Expert Witness Statement

Expert statement regarding Amendment C384 and the properties at 62-70 Gracie Street, and at 49-51 Henderson Street, North Melbourne

Date: Thursday 6 October 2022

Figure 2. Cross section showing terrain cross section and roads relative to this. Purple indicates flood overlay extent proposed through C384 amendment. Hatched areas were determined as flood impacted through Afflux modelling

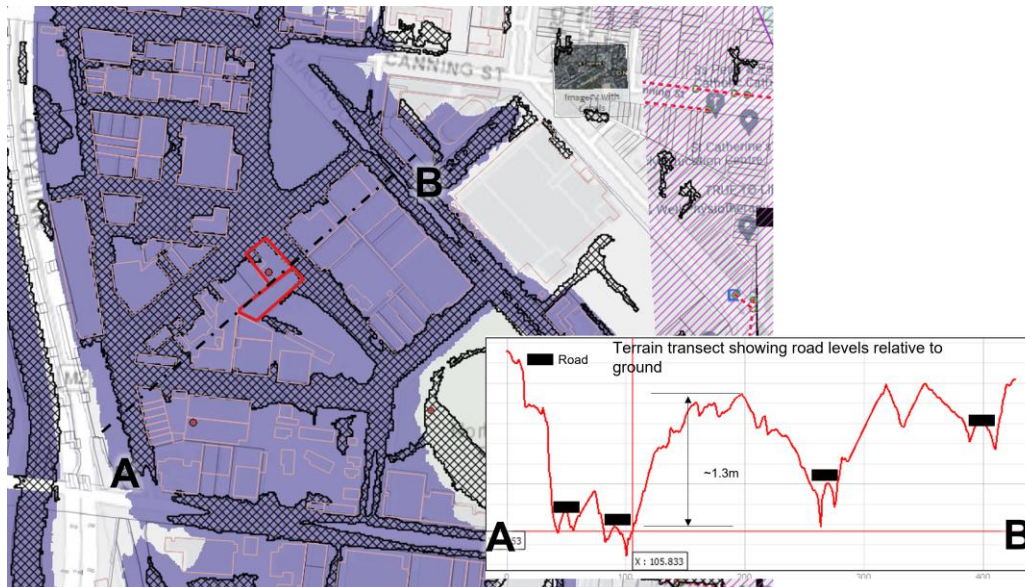
Figure 2 shows a cross section of the terrain through the area. It is evident that the flooding is closely aligned with the roads.

It is possible that the broad extent of flooding near the Moonee Ponds Creek is influenced by escaping flows that overtop the levees. It is possible to 'increase' the flow in the creek to achieve any depth of flooding, as once the water has left the creek channel those same levees prevent it returning. As such the operation of pumps (or not) and the calculations underpinning assumptions for creek flow are critical.
